# Access Compliance Report

## Public Rights-of-Way

Intersection ID: 9446	Main Street: HIGHLAKE_DR	Cross Street: MALIBU_DR	Location: SW
ADA ID: 77BE7F3D777F	Ramp Type: BlendTrans1	Initial Pass/Fail: Fail	Overall Compliance: No
		Severity Score: 25

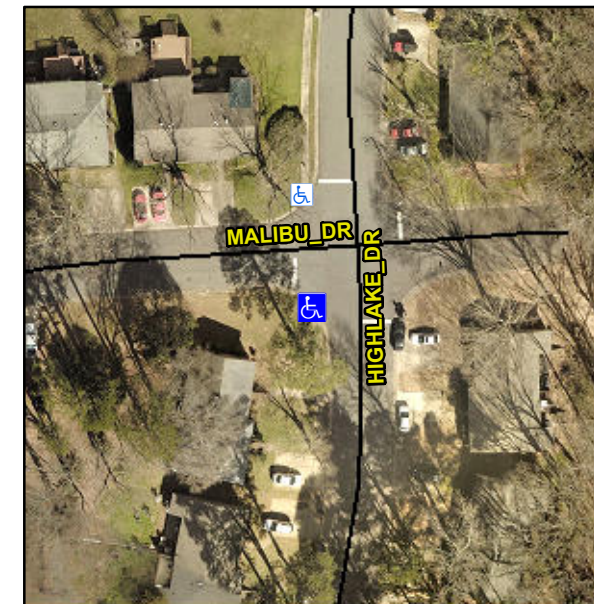
**Not Found, R304.5.3**

Compliance	Description	Data	Compliance	Description	Data
N/A	Ramp Length (in)	58.0	Yes	BlendTrans Slope (%)	0.9
Yes	Ramp Width (in)	48.0	No	BlendTrans XSlope (%)	7.2
N/A	Flare Type LT	N/A	N/A	Flare Type RT	N/A
N/A	Flare Slope LT (%)	N/A	N/A	Flare Slope RT (%)	N/A
N/A	Flare Traversable LT?	N/A	N/A	Flare Traversable RT?	N/A
N/A	Landing Length (in)	N/A	N/A	DWS Provided?	N/A
N/A	Landing Width (in)	N/A	N/A	DWS Contrast?	N/A
N/A	Landing Slope (%)	N/A	N/A	DWS Length (in)	N/A
N/A	Landing X Slope (%)	N/A	N/A	DWS Full Width?	N/A
N/A	Landing Curb? (Y/N)	N/A	N/A	DWS Offset (in)	N/A
N/A	Shared Landing?	N/A			
N/A	Gutter Ponding?	N/A	N/A	Gutter Slope (%)	N/A
N/A	Gutter Lip Ht (in)	N/A	N/A	Gutter X Slope (%)	N/A
N/A	Painted X Walk1?	No	N/A	Painted X Walk2?	N/A
	X Walk 1 Direction	To N		X Walk 2 Direction	N/A
	X Walk 1 Width (in)	N/A		X Walk 2 Width (in)	N/A
	X Walk 1 Slope (%)	4.0		X Walk 2 Slope (%)	N/A
	X Walk 1 X Slope (%)	3.4		X Walk 2 X Slope (%)	N/A

N/A	Ramp inside XWalk1?	N/A	N/A	Ramp inside XWalk2?	N/A
	Road Slope (%)	3.4		Clear Space?	N/A
	Road X Slope (%)	4.0	N/A	Clear Space to XWalk (in)	N/A
N/A	Any Obstructions?	N/A	N/A	Storm Grate/Utility Hazard?	N/A
	Obstruction Type			Storm Grate/Utility Type	
		N/A			N/A
			Yes	Surface Condition? (G/P)	Good
			No	Curb Slope (%)	11.6

**Remove & Replace Curb Ramp With Two New Directional Ramps or Equivalent.**
